TECHNICAL MEMORANDUM 004
NYU CORE
CEQR No. 11DCP121M
ULURP No. C 120124 ZSM

NYU Core

Illustrative Axonometric Views — Proposed Modification (Inclusive of Substantial Compliance Changes) (Tech Memo 003 Figure 5, as revised)

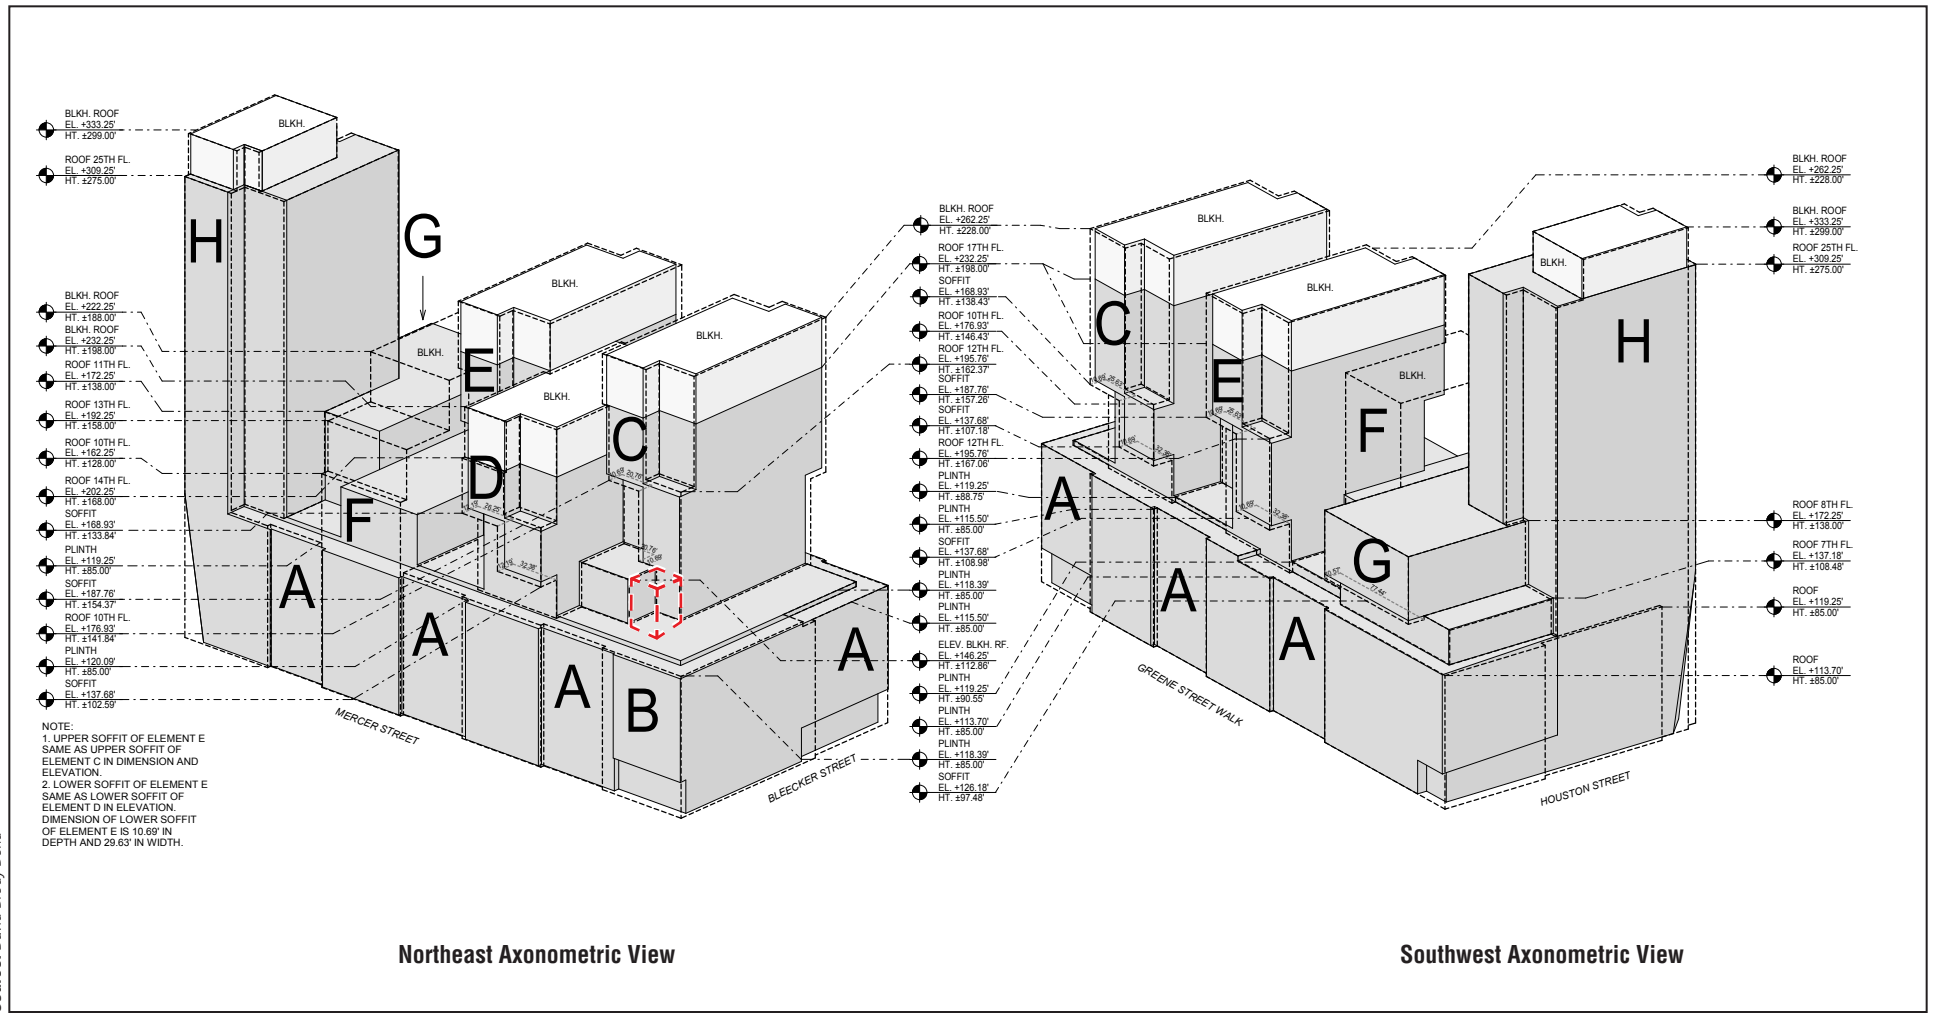
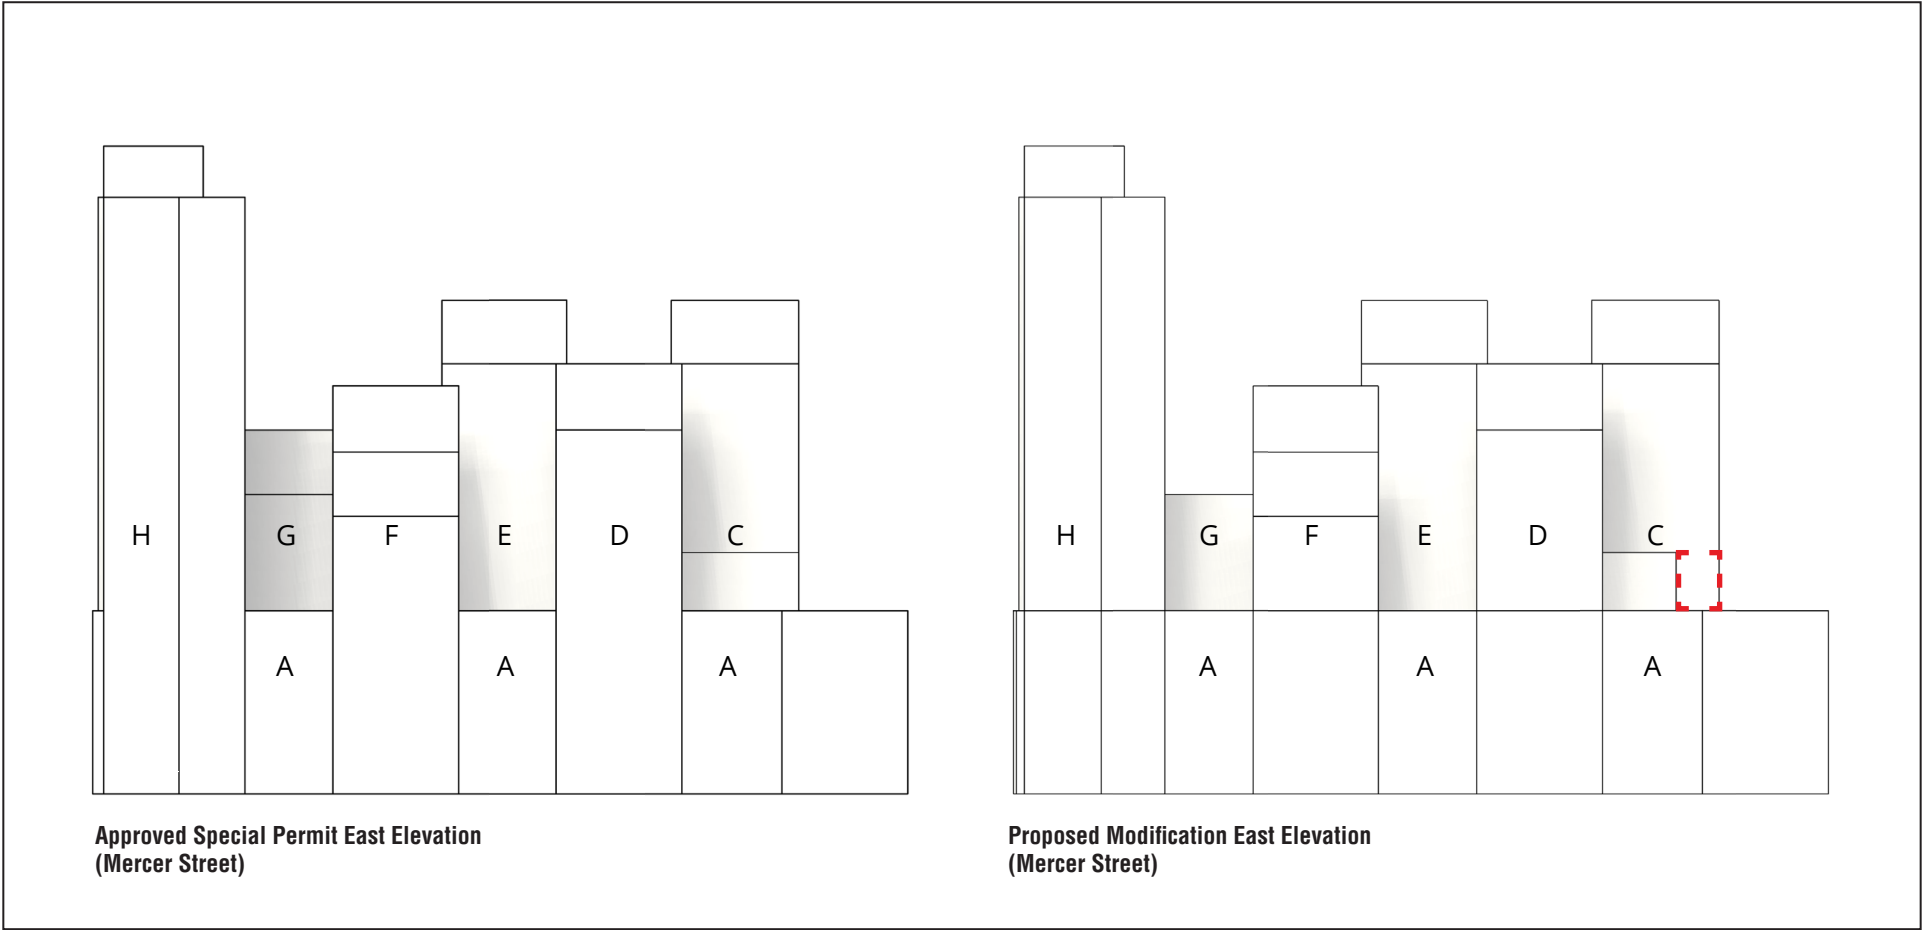
This technical memorandum (Tech Memo 004) presents an adjustment to one of the substantial compliance changes considered in concert with the Proposed Modification in Tech Memo 003. Specifically, as described in Tech Memo 003, during building design and preconstruction planning, an elevator bulkhead at the east face of the "C" tower was added at the base of the tower to accommodate a circulation system that includes corridors, open stairs and associated elevators at the building perimeter. In response to public comments during Community Board review of the application (reflected in the analyses presented in Tech Memo 003), NYU has reduced the size of the elevator bulkhead by eliminating its northern portion (see **Figures 2, 3 and 4** [revised Figures 5, 9 and 10, respectively, from Tech Memo 003]). This adjustment would result in a minor reduction in bulk (420 square feet), and therefore would not have the potential to alter the findings presented in the FEIS and subsequent technical memoranda, including Tech Memo 003 findings with respect to shadows, urban design and visual resources, or neighborhood character. The adjustment would not alter the bulk of Tower C as viewed from the public realm,

PORTION OF ELEVATOR BULKHEAD REMOVED

Roof Plan Comparison
(Tech Memo 003 Figure 10, as revised)

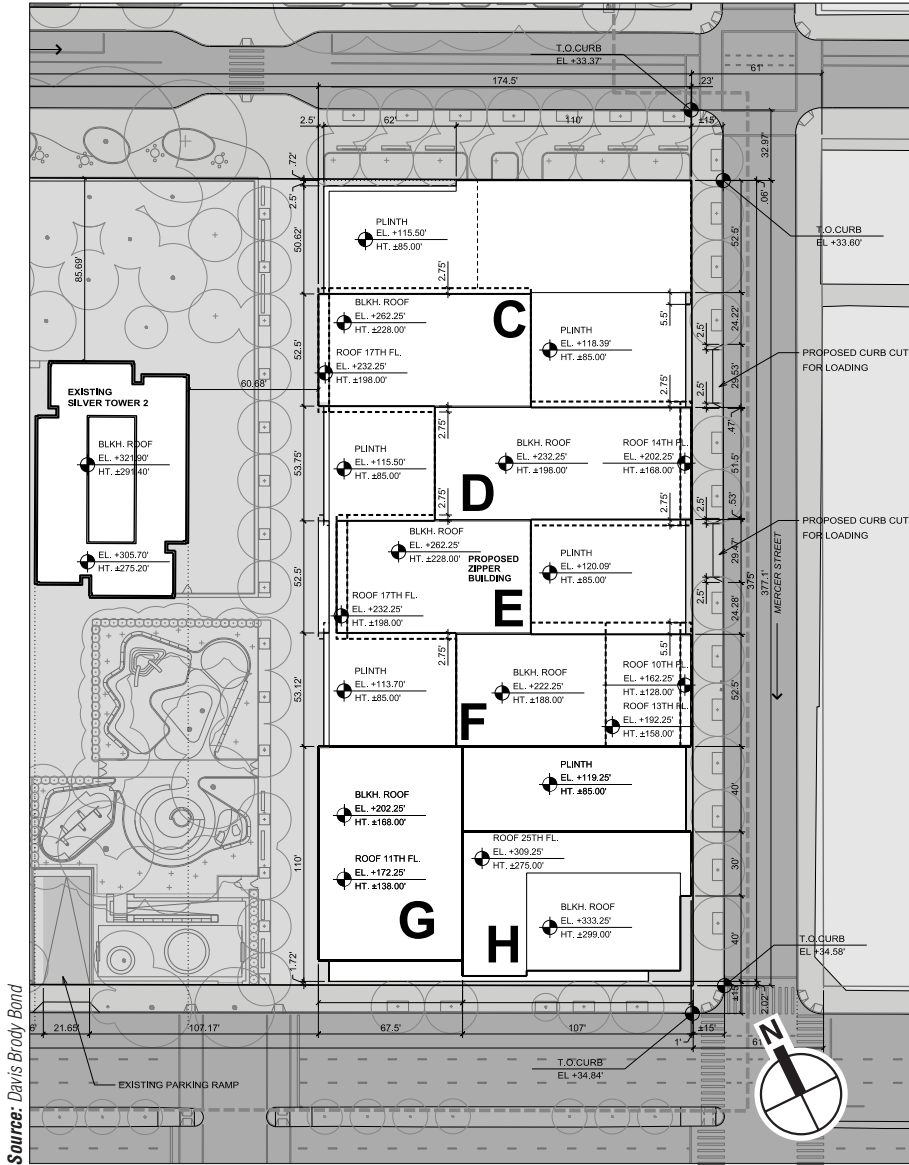
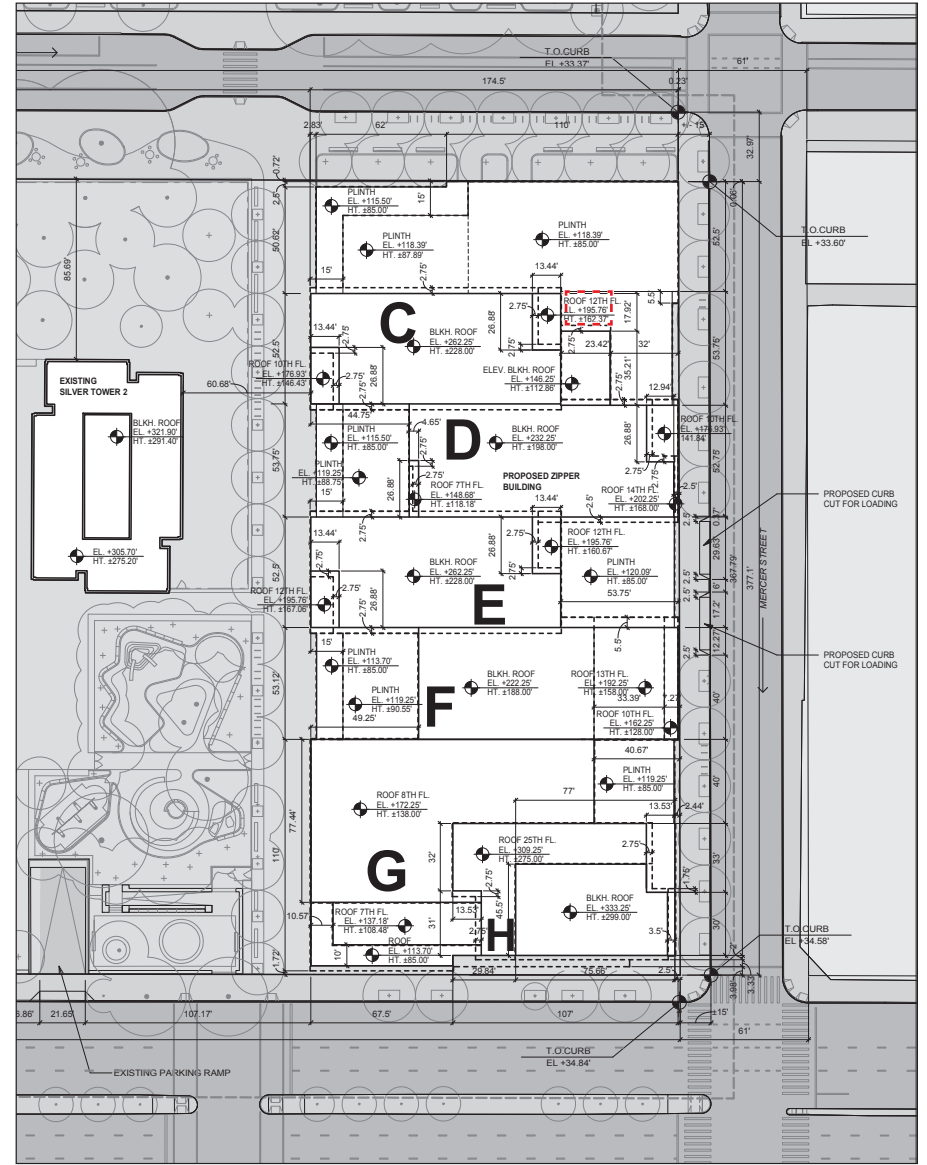
PORTION OF ELEVATOR BULKHEAD REMOVED
